Traditions II - Block 349 Medium Density

Servicing and Stormwater Management Report

**Reference: 1883 Stittsville Main
Response to First Formal Review Comments (D07-12-24-0142)
Our File No.: 124097**

TRADITIONS II - BLOCK 349		
POST-DEVELOPMENT STORM DRAINAGE AREA PLAN		
SCALE 1 : 750	0 10 20 30	FIGURE 5.1
DATE JUL 2025	JOB 124097

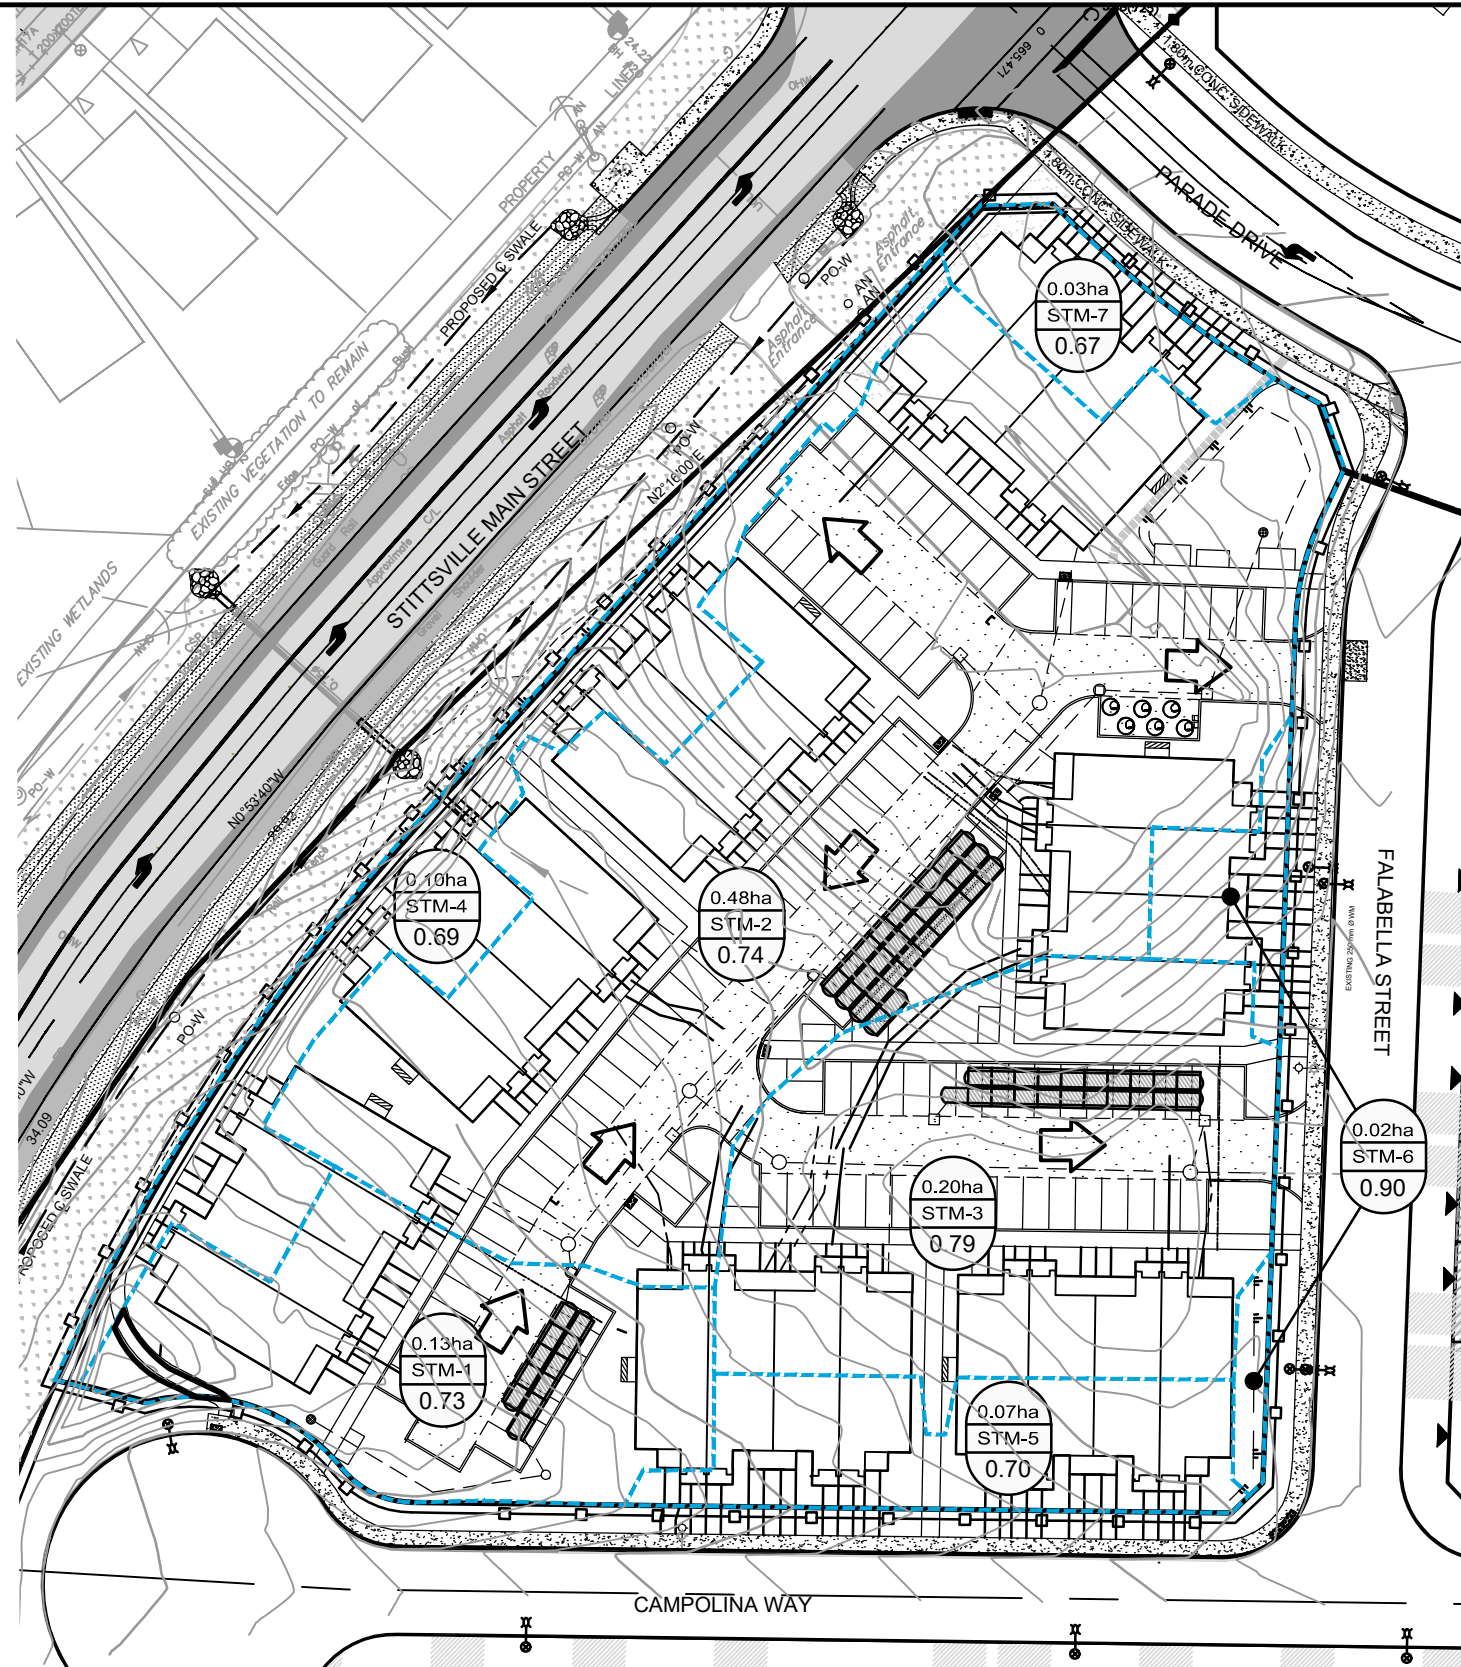
12. Section 4.3.3: The report does not list Area STM-7 Uncontrolled, when compared to Figure 5.1.

Response: Report revised.

**FIRE HYDRANT COVERAGE
PLAN**

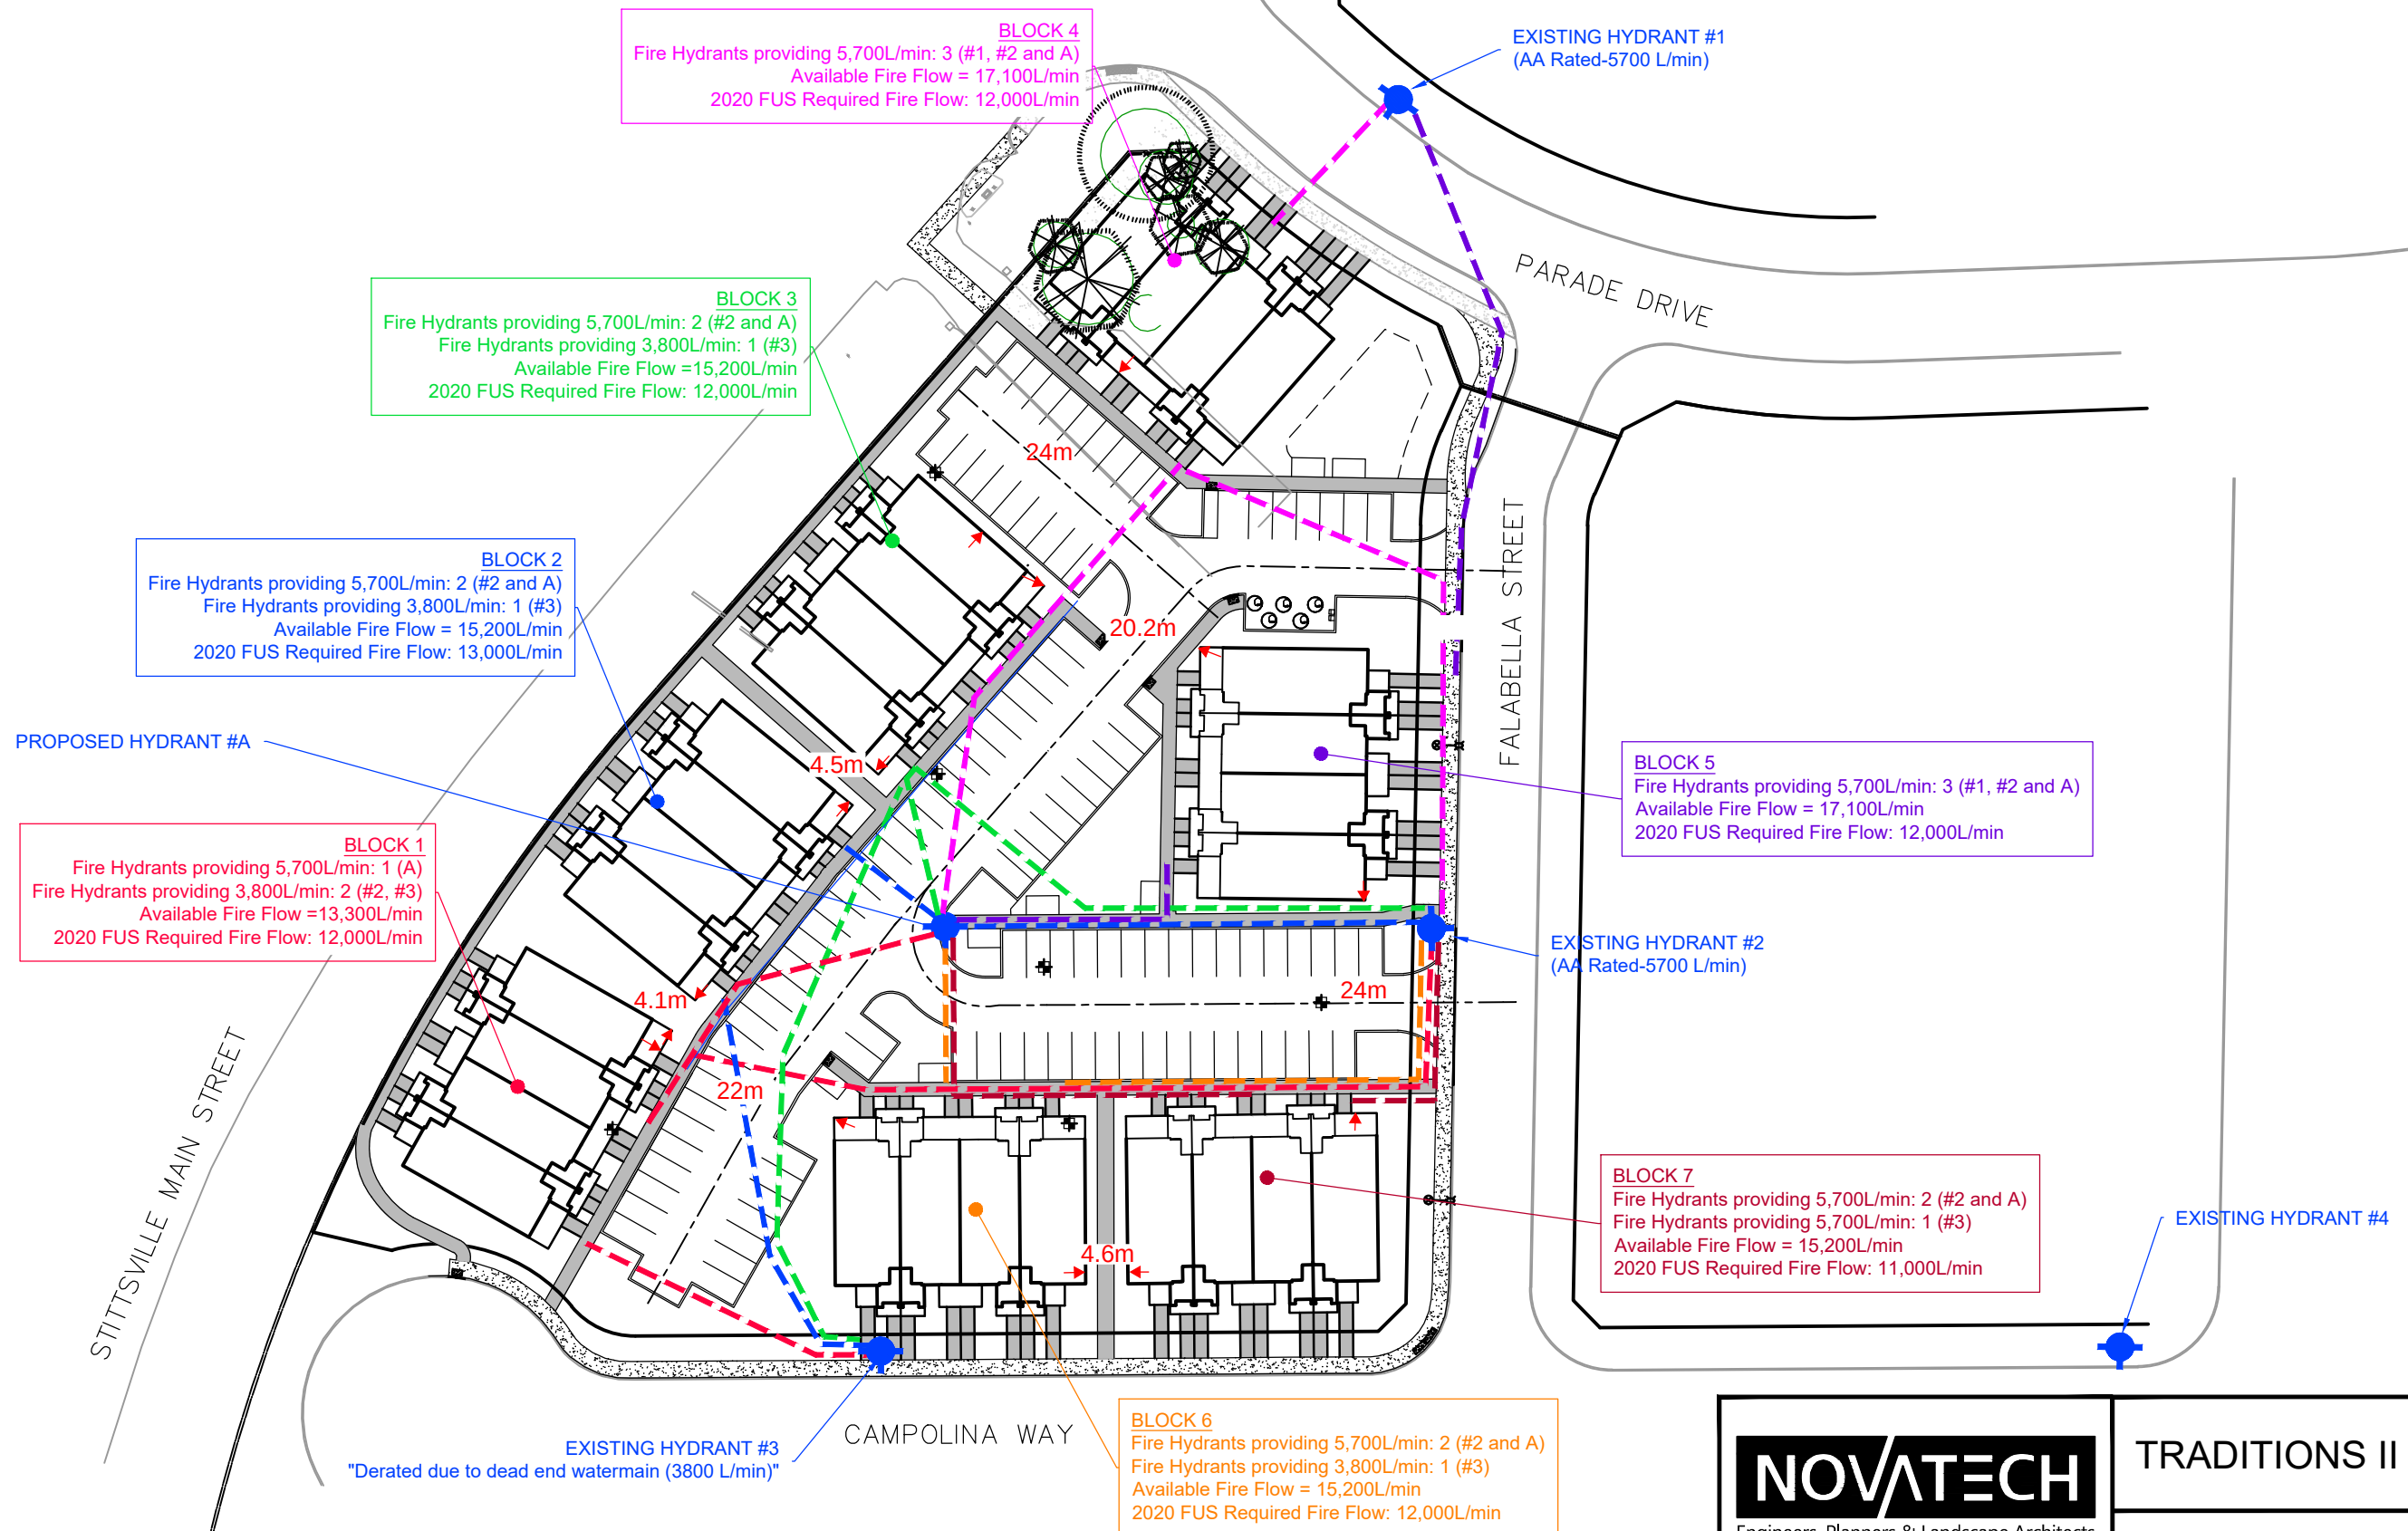
21. Appendix E: Please re-check your exposure distances. Some of the building offsets and Description/Address noted in the Table 6 Worksheets appear to be incorrect. Exposure distance figure for Block 4 and Block 5 is missing.

Response: Exposure distances for all blocks have been added to Figure 7.1

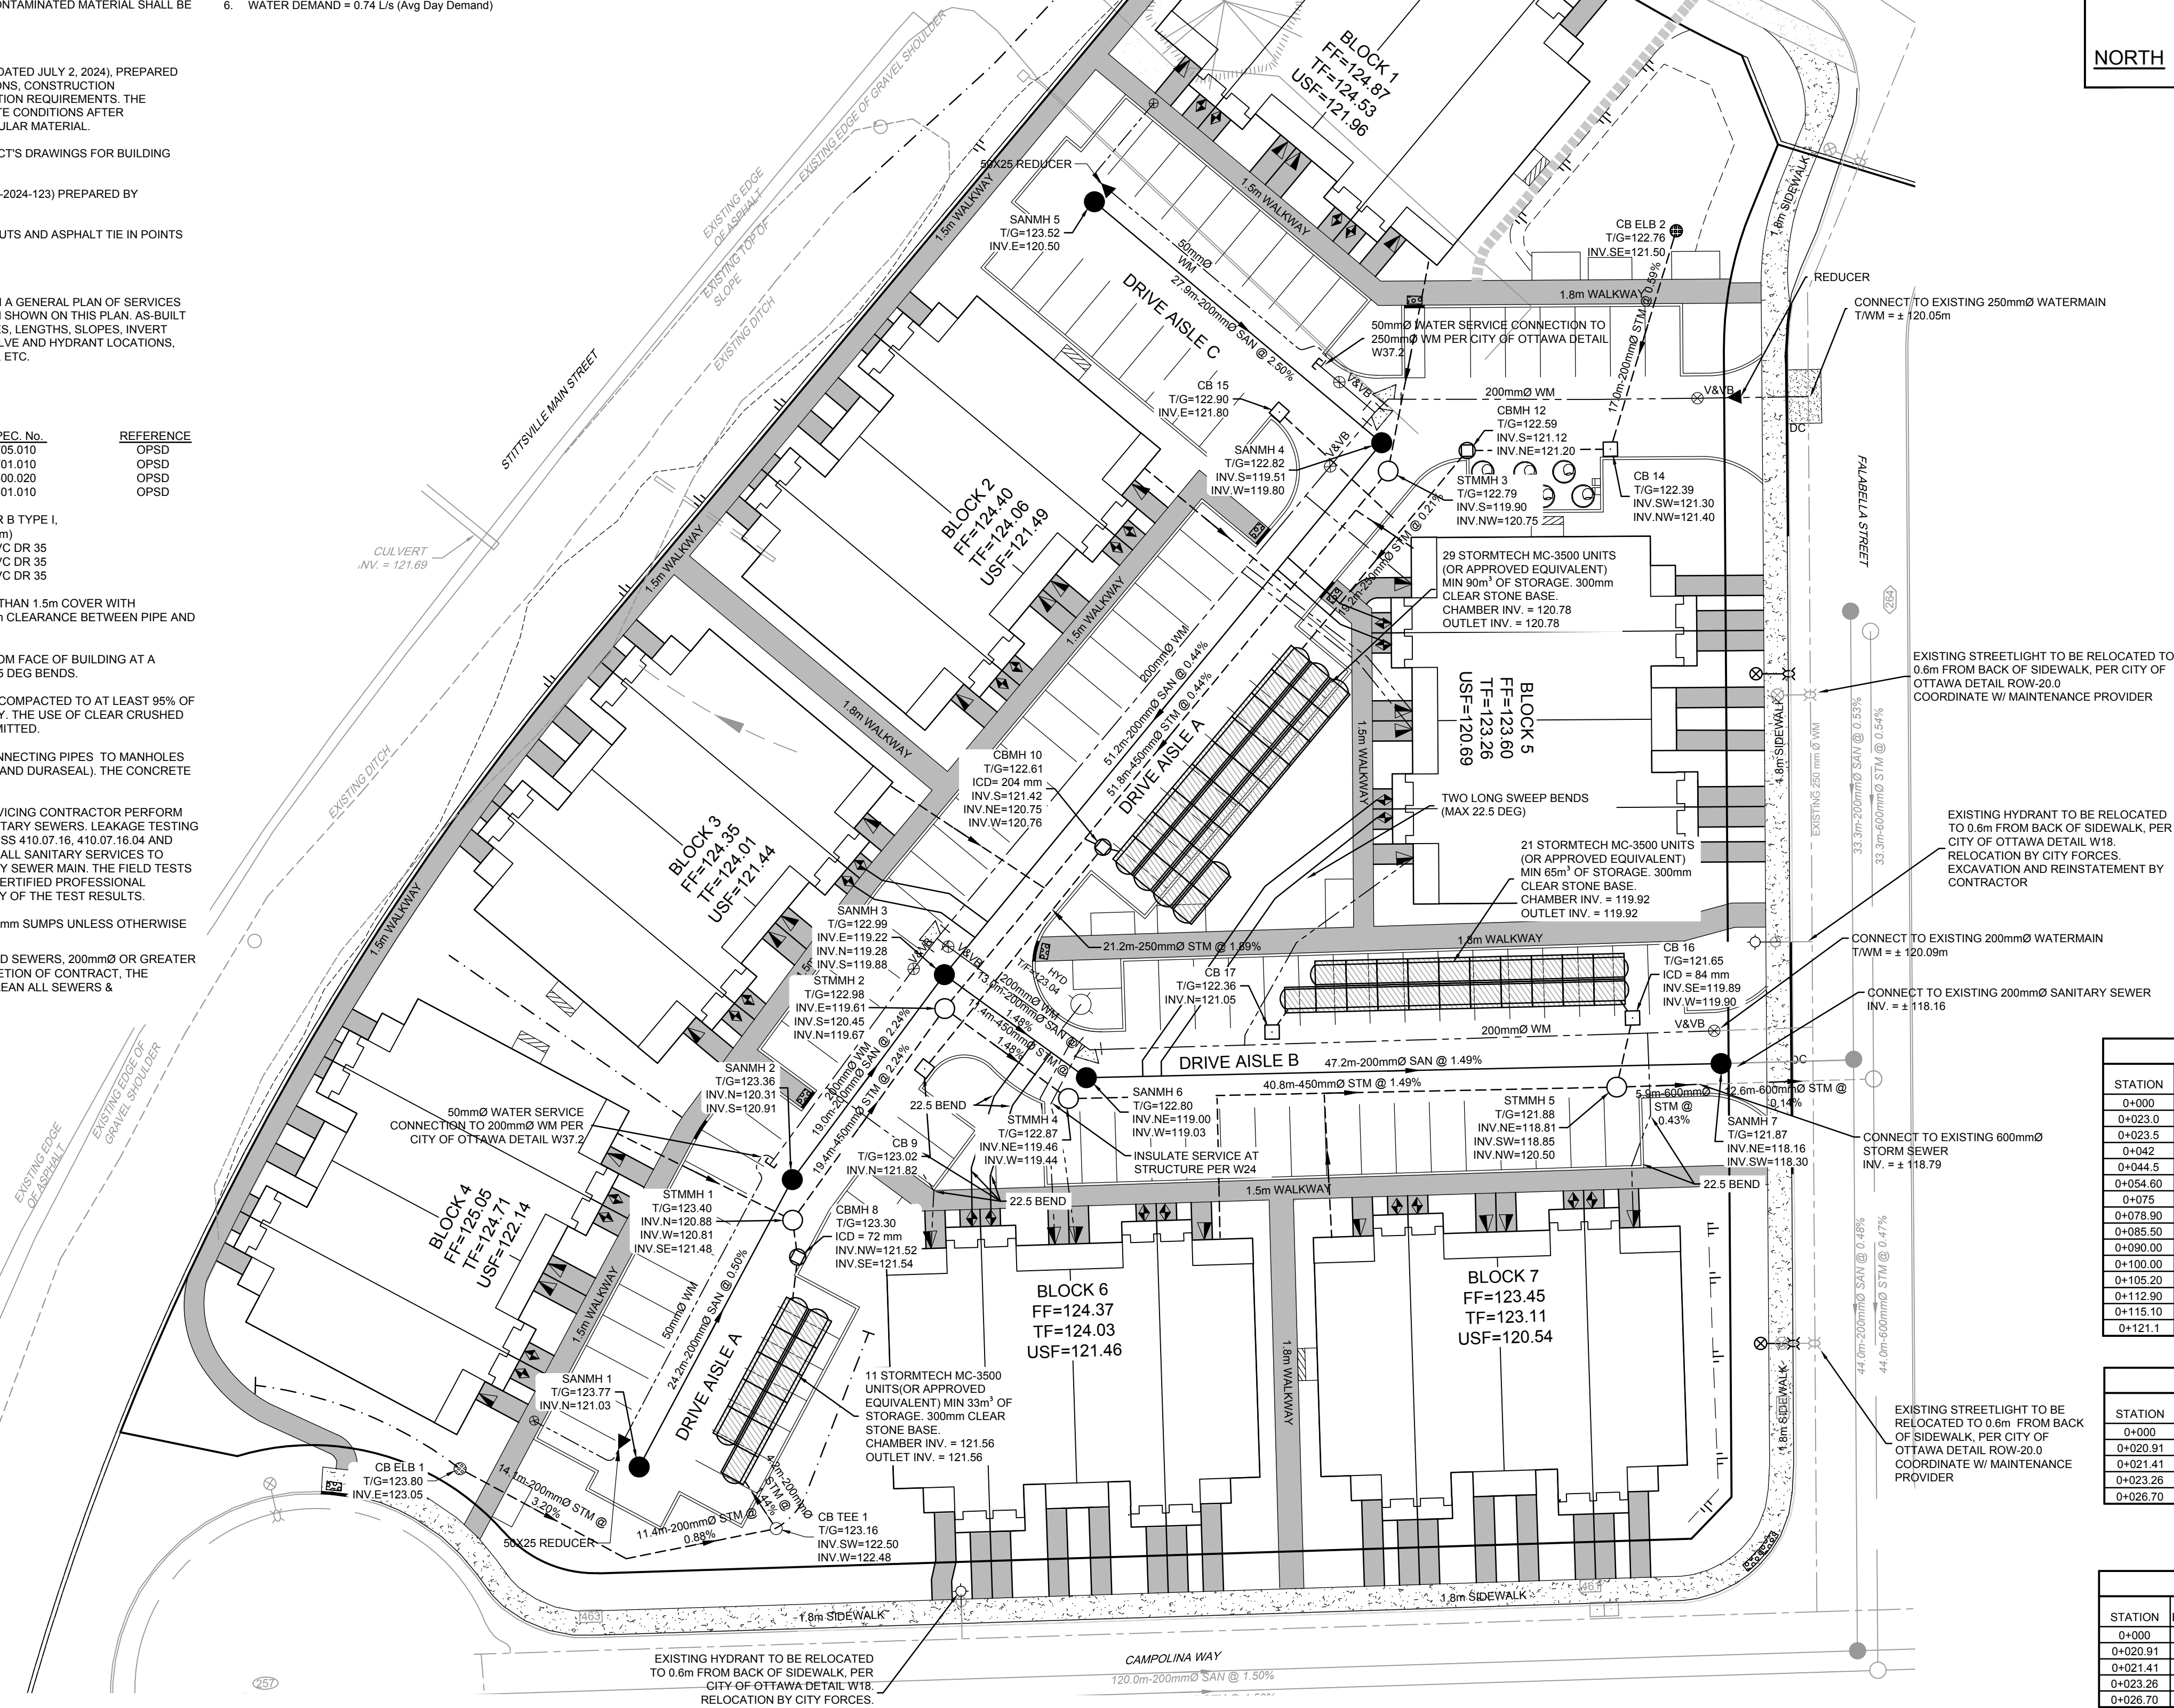
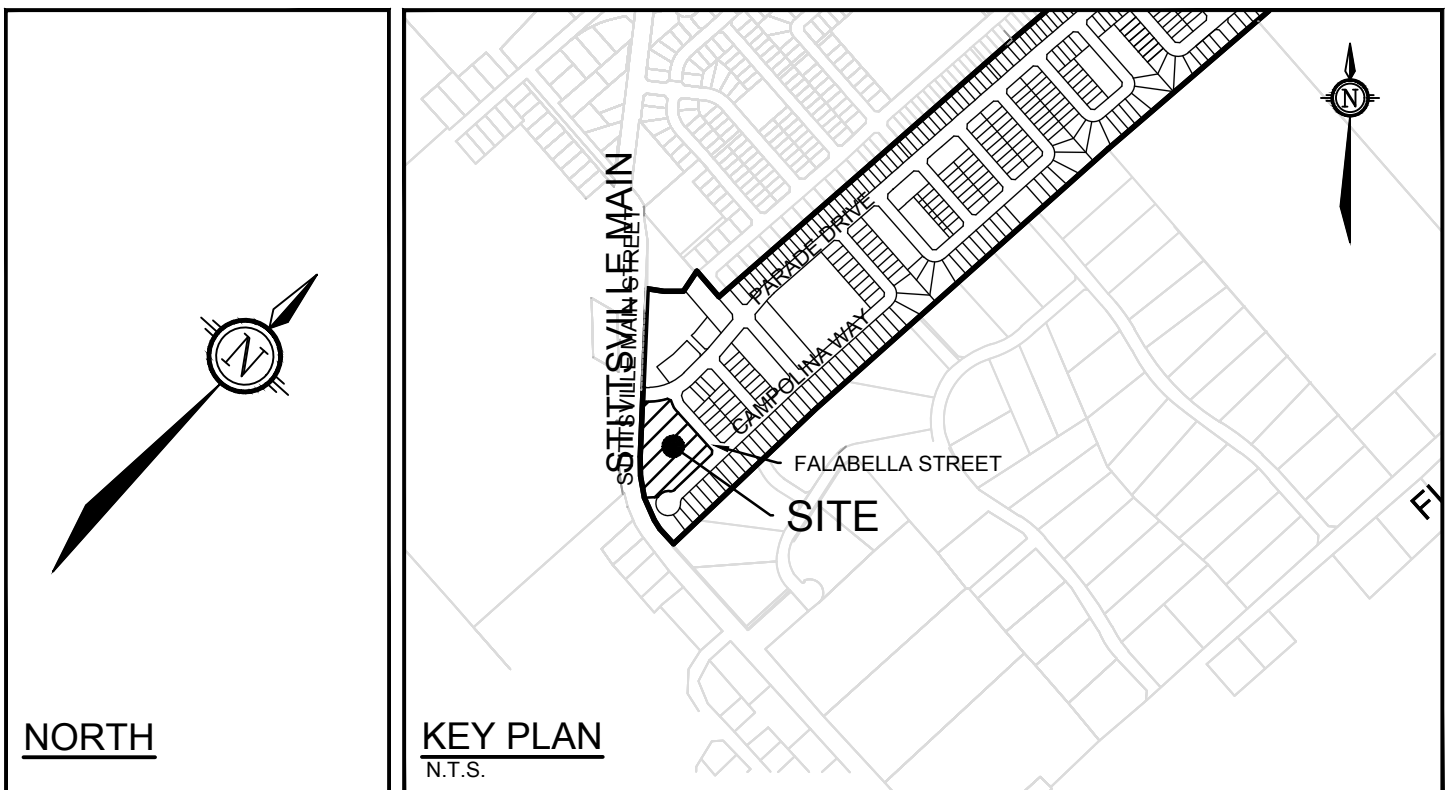
28. Please note the ICD locations and sizes on the plan.

29. The existing watermain stub is 200mm diameter. Please update on the plan.

Response: Plan revised.

Response: Plan revised.
